工程指示 / 要求簡箋(E.I.)

工程指示編號 : EI / 594⁵ / 23

工程名稱 : 將軍澳 w 日出康城 LP 11

工程項目 : 幕牆 拆圖修改 廠安防火棉和棉叉

名稱	47工牌	制圖	曾建平	2017.06.05	修改		
材料	1.5mm 鋁	復核	王德	2017.06.05	日期	J858-MC1	
顏色	MILL	批准			圖號	J858 MC1

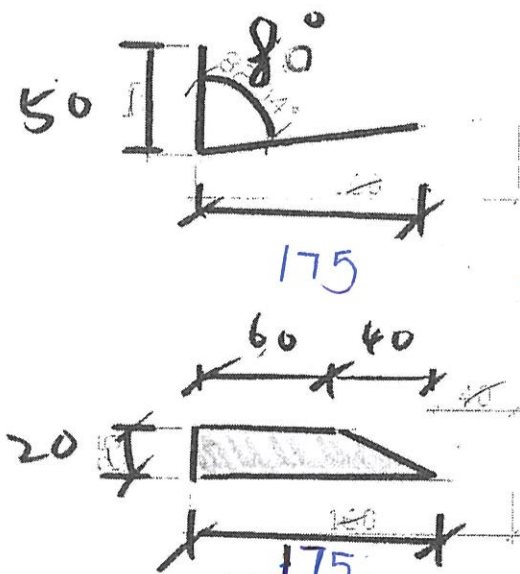
凡有飾線的單元件, 防火棉需由廠安裝時。

需要加棉叉才能固定, 避免運輸時脫落。

請修改拆圖有飾線的單元件, 需用棉叉固定防火棉。

隔棉用
~~50棉用~~

廠用陶然棉棉
數量見B.M表

棉又供隔棉用

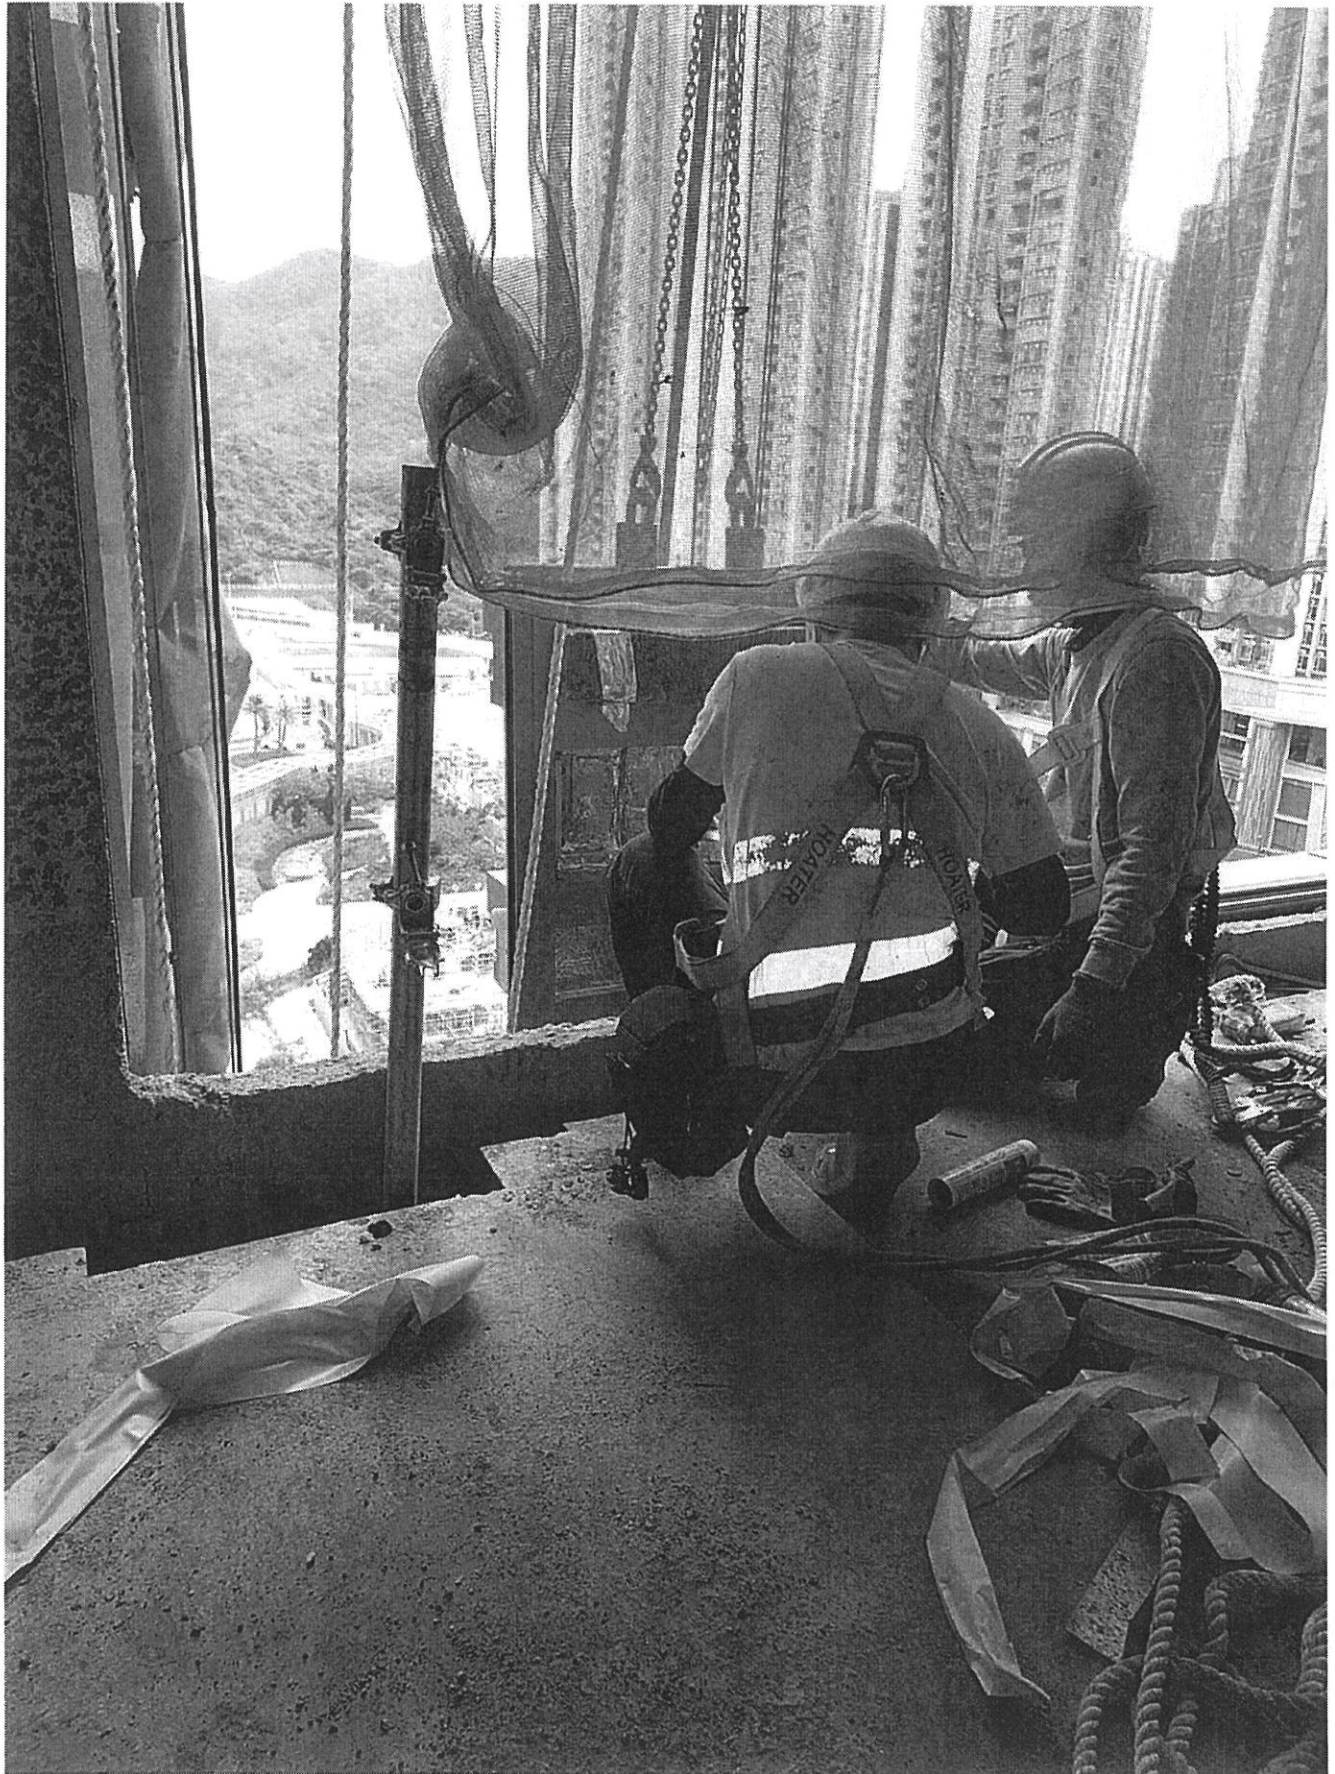
L 版：因應地盆安裝時，原本在地盆安裝的防火棉托，會阻礙安裝有飾線的單元件。

所以凡有飾線的單元件此防火棉需改由廠安裝。顧問已同意。(附報告)

*請留意 防火棉需貼上錫紙，錫紙包好完整，務不露出防火棉。

參考相片，該個飾線背空間全裝密，單元背凸出30MM便可以，唔夠地盤後補。

需用锡纸包好
完整

Photo 1

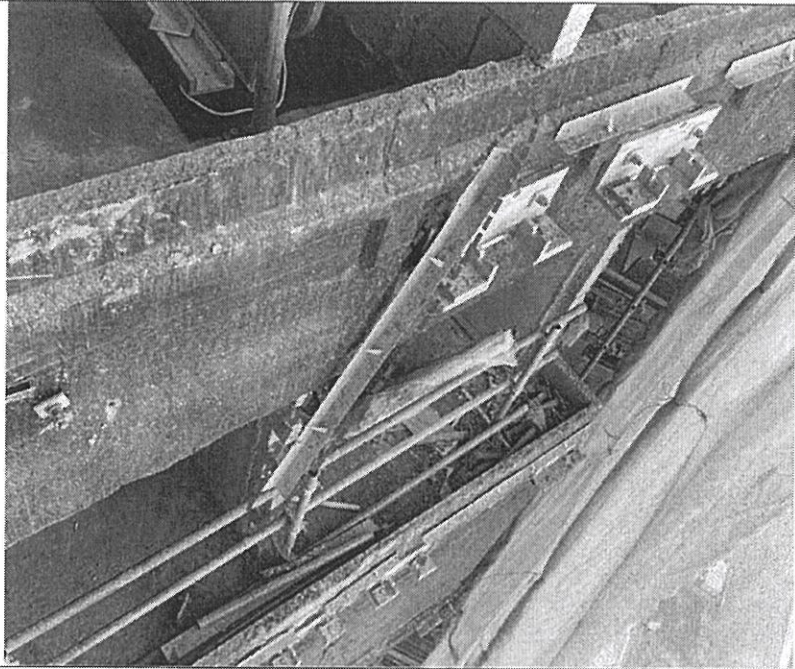
The retainer plate for fire insulation was observed to be damaged on the 12/F slab. It was removed after informed of MIDI.

Photo 2

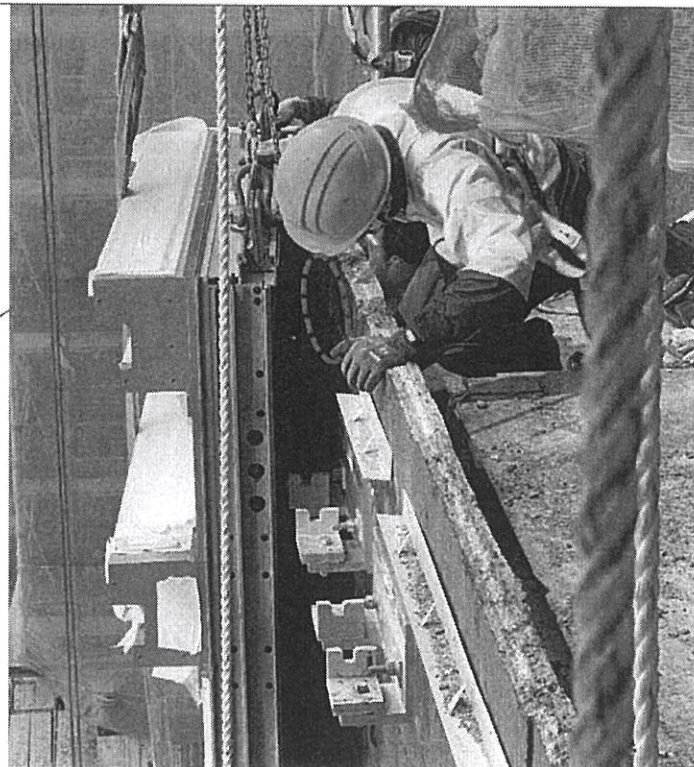
The retainer plate was observed to be removed due to the it will clash with unit during installation.

Photo 3

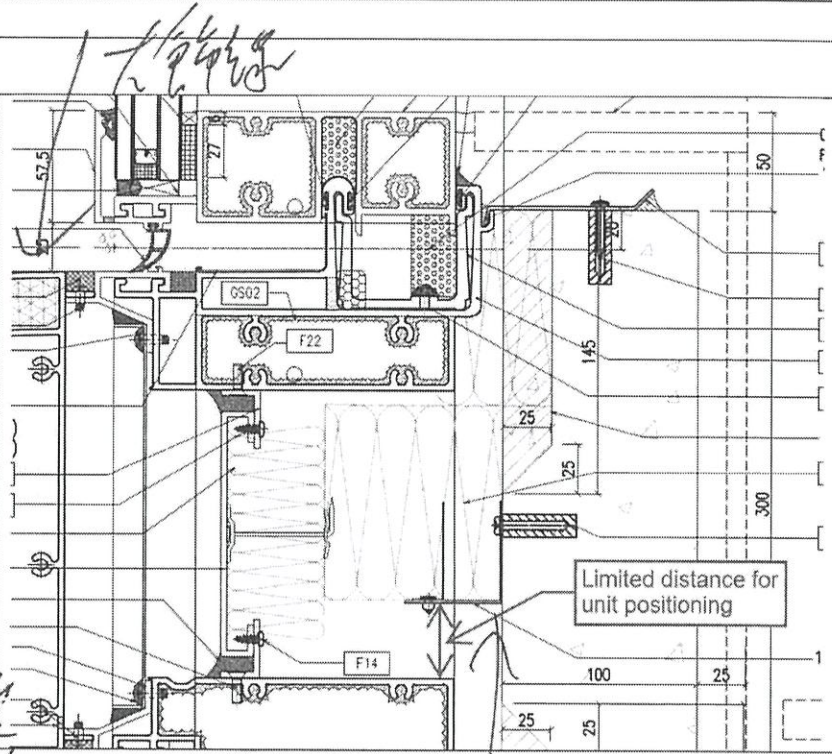
The retainer plate will clash with unit due to it limits unit movement for positioning.

防力掙托, 阻礙
有鎖線零件

It was coordinated and agreed that the fire insulation was pre-mounted onto spandrel position for formal installation.

需用錫紙包好 (7/2 示範)
(防熱包好, 不露路士棉)

Photo 7

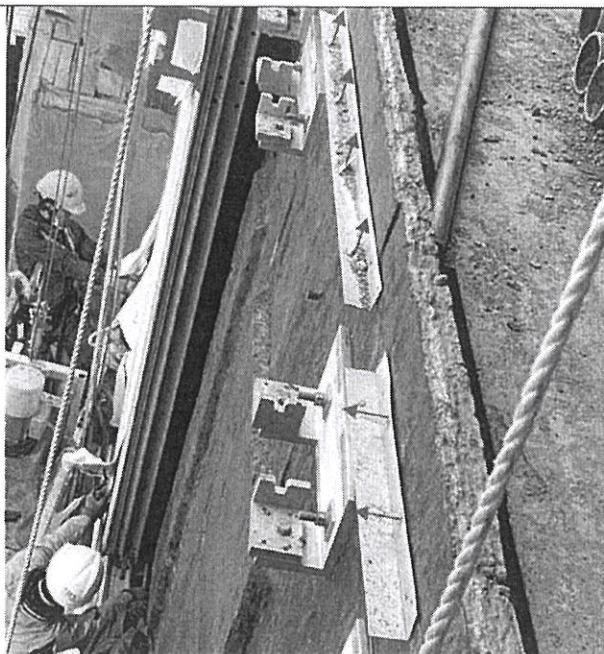
The installed retainer plate was observed to be with different orientation.
